# AMERICAN GEOTECH, INC.

**SUBJECT: EPA SUPERFUND SITE #3-HW-21  
BERKS LANDFILL  
REVIEW COMMENTS ON GOLDER'S  
DRAFT REMEDIAL INVESTIGATION REPORT  
SUPPLEMENT TO MY MARCH 11, 1994 LETTER**

FIGURE 1 - Existing Cap Conditions

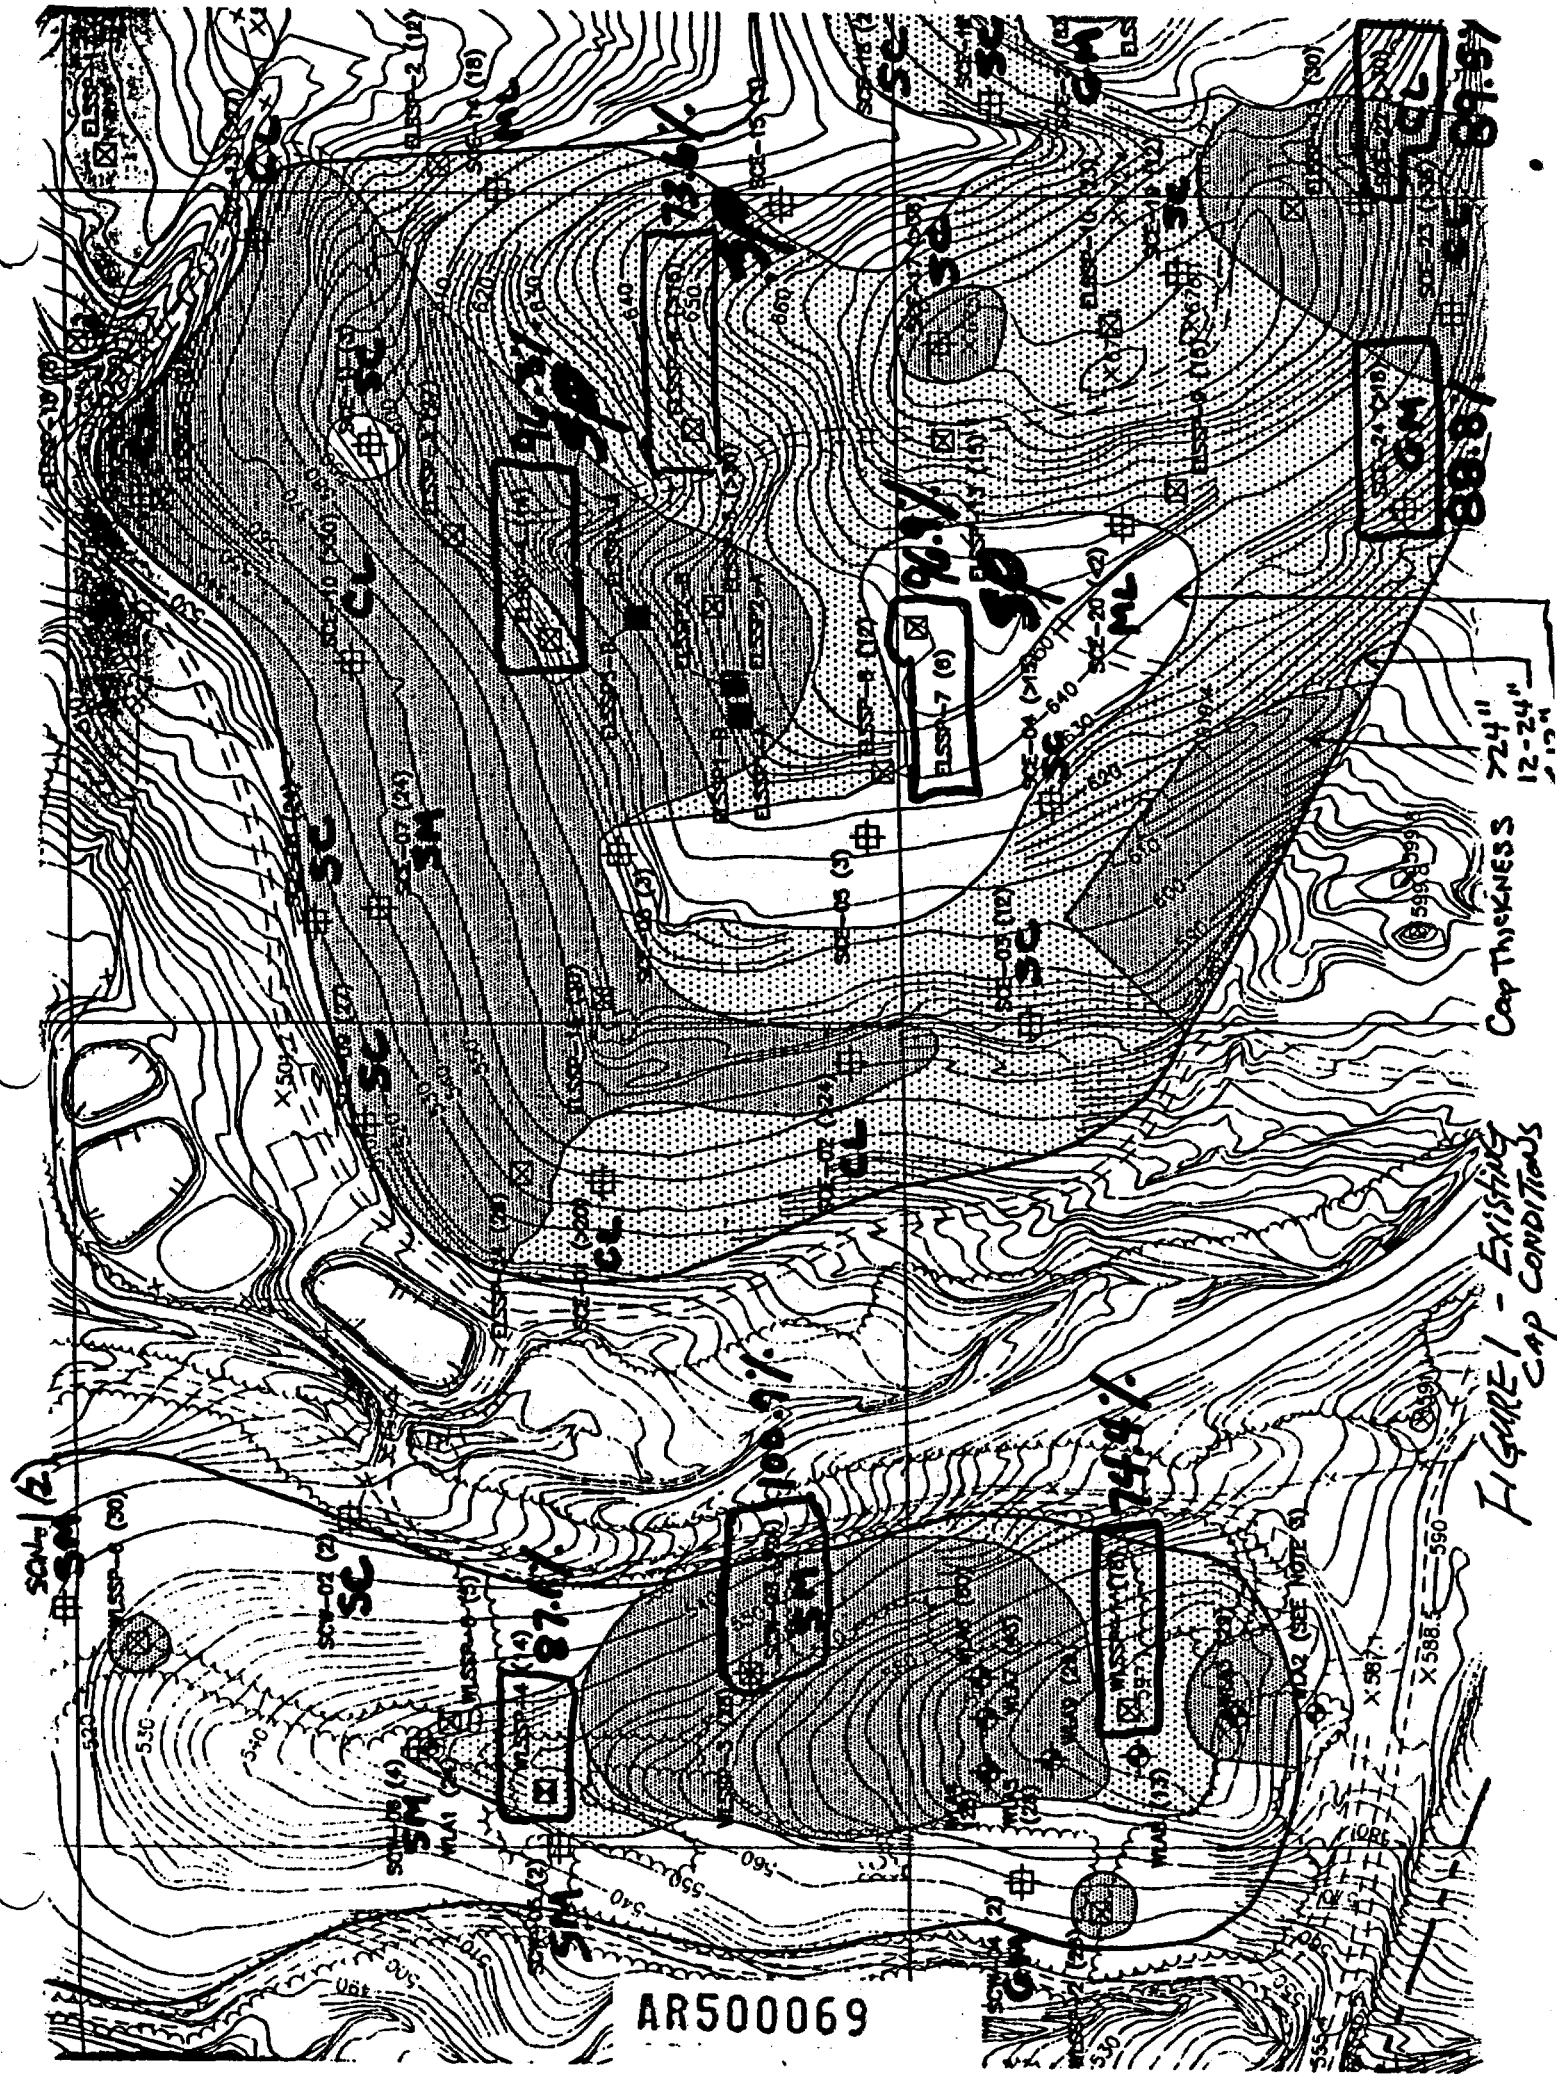
However, our findings do not agree with Golder's. We have summarized Golder's field and laboratory test results in Table 1 and Figure 1 and have the following conclusions:

- The actual cap thicknesses vary from less than 2" to 36". More than 60% of both landfill areas have the thickness less than the specification (2').
- The capping materials consist of silty sand, fine to medium sand, silty gravel, clayey sand, or silty clay. More than half the landfill caps do not contain clayey materials.

- Out of 8 field density tests (73.6% to 100.9%), 5 of the tests were below 90% of the standard proctor density. Golder's acceptance criteria were based on average value and are totally unacceptable.
